To: Brad Kosco, PE, PS – City of Hudson
From: GPD Group
Cc:

Technical Memorandum: Darrow Road Park Basin Hydrologic & Hydraulic Study

Comment Responses

Figure 2: Proposed PCSWMM Schematic (**Storage Alternative 1**)

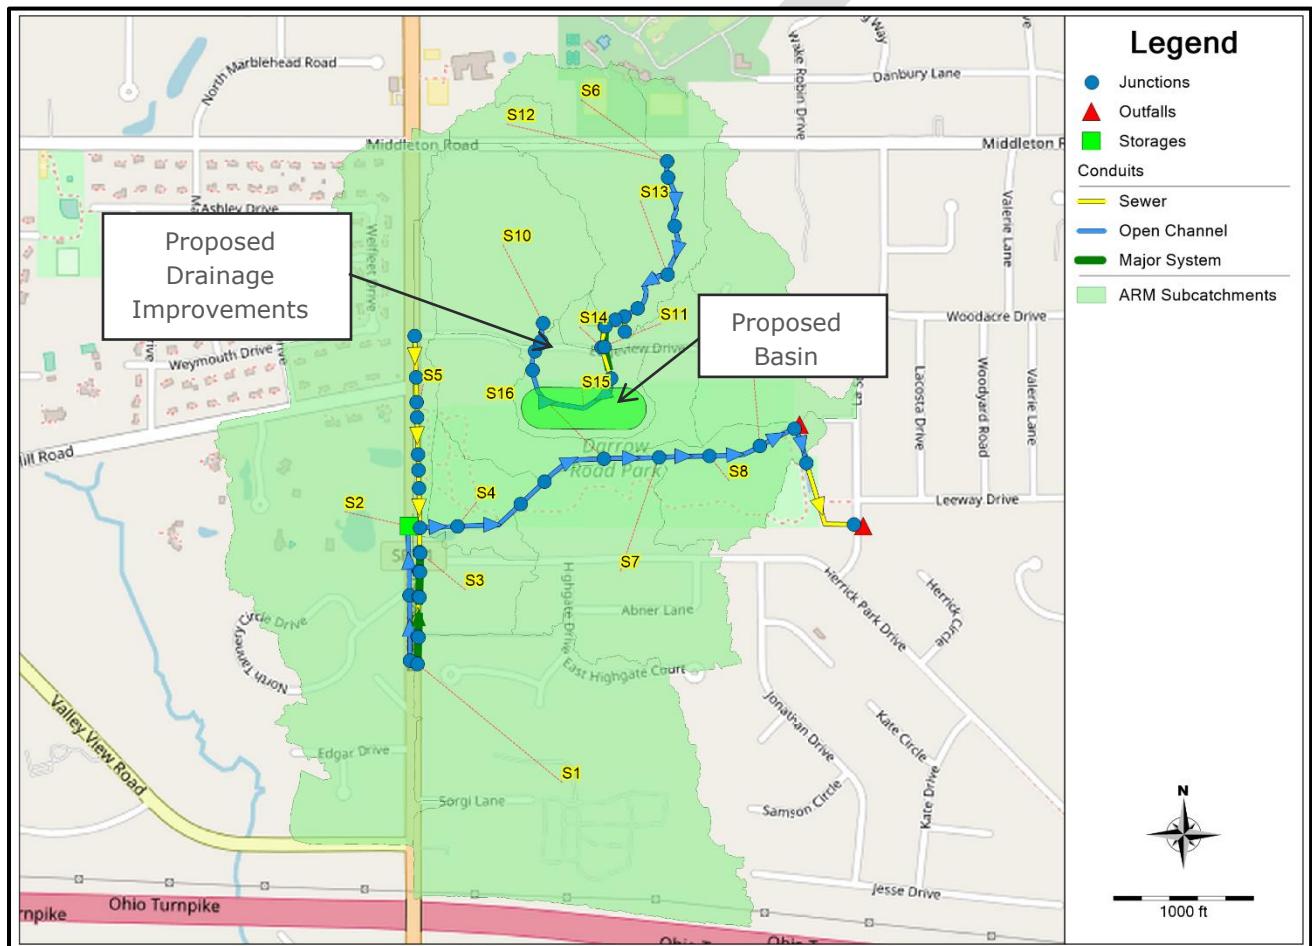
City comment: Why isn't more pond volume being utilized in the scenario presented.

GPD response: The basin size and footprint were somewhat arbitrary. We had a set height we were targeting to not back up water onto the properties to the north and to keep it out of being regulated by ODNR. We made a large basin to be sure that we had enough storage, knowing that if the project was pursued, it could be right sized based on the volume needed.
